Manston Airport DCO Application: Review of noise documentation following noise hearing

Report for Thanet District Council, 2nd May 2019

The figure below is part of the applicant response for request 7.

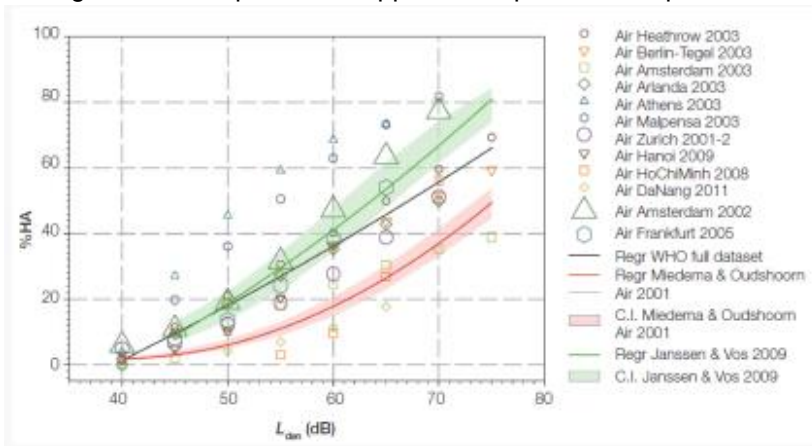
Request	Applicant response	Assessment of applicant response	Recommendation
	<p>There is a large variation in the ERFs between the studies, however, a clear relationship between increasing annoyance with increasing noise level can be seen. WHO undertook a regression analysis of the data in all studies to generate an ERF. This is shown as a black line in the figure.</p> <p><i>[Note: see figure provided beneath this Table 2.1.]</i></p> <p>It is important to note that WHO’s most recent guidance provides guidance on the onset of effects. It does not define limit values, nor does it set “effect levels” (LOAEL, SOAEL UAEL etc). The WHO Environmental Guidelines for the European Region (2018) state that “data and exposure–response curves derived in a local context should be applied whenever possible to assess the specific relationship between noise and annoyance in a given situation”. This is acknowledged by Government in their draft aviation strategy who make the following statement on the WHO 2018 guidance: “3.106 There is also evidence that the public is becoming more sensitive to aircraft noise, to a greater extent than noise from other transport sources, and that there are health costs associated from exposure to this noise. The government is considering the recent new environmental noise guidelines for the European region published by the World Health Organisation (WHO).⁷³ It agrees with the</p>

Request	Applicant response	Assessment of applicant response	Recommendation
	<p>ambition to reduce noise and to minimise adverse health effects, but it wants policy to be underpinned by the most robust evidence on these effects, including the total cost of action and recent UK specific evidence which the WHO report did not assess.”</p> <p>Since the EIA for Manston Airport commenced, government has set LOAEL values for aircraft noise in its Response to consultation on noise policy in 2017:</p> <p>“2.70 The government acknowledges the evidence from recent research which shows that sensitivity to aircraft noise has increased, with the same percentage of people reporting to be highly annoyed at a level of 54 dB LAeq 16hr as occurred at 57 dB LAeq 16 hr in the past. The research also showed that some adverse effects of annoyance can be seen to occur down to 51dB LAeq.</p> <p>2.71 Taking account of this and other evidence on the link between exposure to noise from all sources and chronic health outcomes, we will adopt the risk based approach proposed in our consultation so that airspace decisions are made in line with the latest evidence and consistent with current guidance from the World Health Organisation.</p> <p>2.72 So that the potential adverse effects of an airspace change can be properly assessed, for the purpose of informing decisions on airspace design and use, we will set a LOAEL at 51 dB</p>

Request	Applicant response	Assessment of applicant response	Recommendation
	<p>LAeq 16 hr for daytime, and based on feedback and further discussion with CAA we are making one minor change to the LOAEL night metric to be 45dB LAeq 8hr rather than Lnight to be consistent with the daytime metric. These metrics will ensure that the total adverse effects on people can be assessed and airspace options compared. They will also ensure airspace decisions are consistent with the objectives of the overall policy to avoid significant adverse impacts and minimise adverse impacts.”</p> <p>The “recent research” referenced is the CAA’s 2014 Survey of Noise Attitudes (SoNA 2014). SoNA 2014 sampled populations living near nine airports in England (Birmingham; East Midlands; Gatwick; Heathrow; London City; Luton; Manchester; Newcastle; and Stansted), with 77% of the sample living around Heathrow airport.</p> <p>The ERF derived from the SoNA study is presented below .</p> <p><i>[Note: see the table provided beneath this Table 2.1.]</i></p>

Figure 2.1 LAeq,8hr Contours From Ecological Chapter

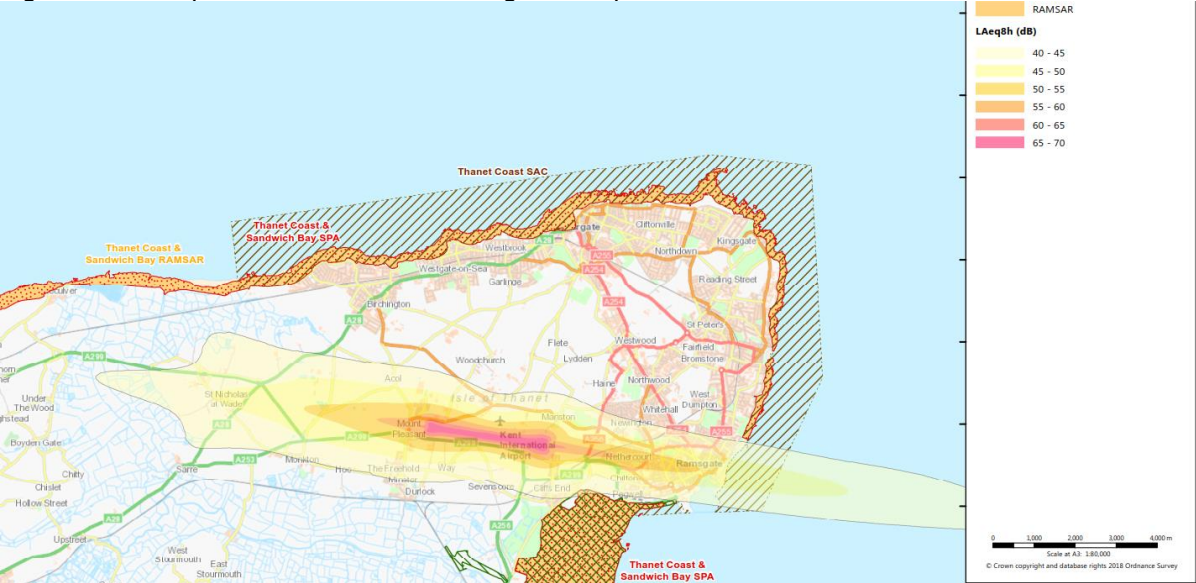
<p>5. combined aircraft and traffic LAeq 16 hour and 8 hour contours if the traffic noise component exceeds screening</p>	<p>We are not aware of any previous Environmental Impact Assessment (EIA) noise assessment where significant effects are determined using combined aircraft and road traffic noise contours.</p> <p>It is widely accepted that people respond differently to noise from different sources. This is illustrated by the evidence presented in the most recent World Health Organisation (WHO) guidance on noise (Environmental Noise Guidelines for the European Region, WHO 2018) which sets out separate source specific guideline values and noise dose-response</p>	<p>The Applicant is unaware of any EIA where significant effects are determined using combined aircraft, and road traffic noise contours. The Applicant further states that the separate source specific guideline values and noise dose-response relations for road and aircraft noise are described in the WHO Guidelines for the European Region 2018. The Applicant further considers that no guidance is provided for assessing the combined effects of exposure to multiple sources. The Applicant considers that conventionally noise from separate sources for airport applications is dealt with separately and is considered not feasible to derive a “cumulative noise impact”.</p>	<p>Request consideration of the cumulative impact of combined development noise levels at receptors through combined predictions and contour maps.</p>

Request	Applicant response	Assessment of applicant response	Recommendation
	<p>relationships for Road, Rail and Aircraft noise. No guidance is provided for assessing the combined effects of exposure to multiple sources of noise. Whilst total noise from multiple sources can be determined, there is no reliable dose-response data to show what the effect of these combined sources of noise is on people. Therefore, it is more appropriate to consider the noise sources separately and determine the overall effect.</p> <p>We are therefore confident that the approach taken in the Environmental Statement (ES) is robust and any revised transport modelling that may be undertaken to confirm significant impacts should adopt a receptor-based approach, rather than a noise contour approach.</p>	<p>ProPG (Professional Practice Guidance on Planning & Noise) provides guidance on the assessment of cumulative noise from transport sources on new residential development. ProPG uses the combined free-field noise level from all transport sources and also commercial noise where the character of the commercial noise is not dominant to provide an initial risk of noise at proposed development sites. The area within the 50 dB $L_{Aeq,8hr}$ contour, which can be found in the Ecology Chapter of the ES (shown in Figure 2.1 included below) and above would be classified as “Medium Risk” and an Acoustic Design Statement would be required to demonstrate how the adverse impacts of noise would be mitigated and minimised and also be required to clearly demonstrate that a significant adverse noise impact is avoided.</p> <p>The IEMA Guidelines for Environmental Noise Impact Assessment recommend that the change in noise levels as well as the absolute noise levels are considered. At present the noise assessments do not consider the total noise level or the total change in noise levels and so the ‘with development’ and the ‘without development’ scenarios are difficult to fully consider.</p> <p>It is noted that without the consideration of the cumulative sources noise of air noise, ground noise, traffic noise and plant noise the predicted significance of the effect may be understated.</p> <p>It is understood the noise assessments of the for the Heathrow expansion DCO are using combined noise impact contours.</p> <p>Note: See Figure 2.1 beneath this Table 2.1.</p>
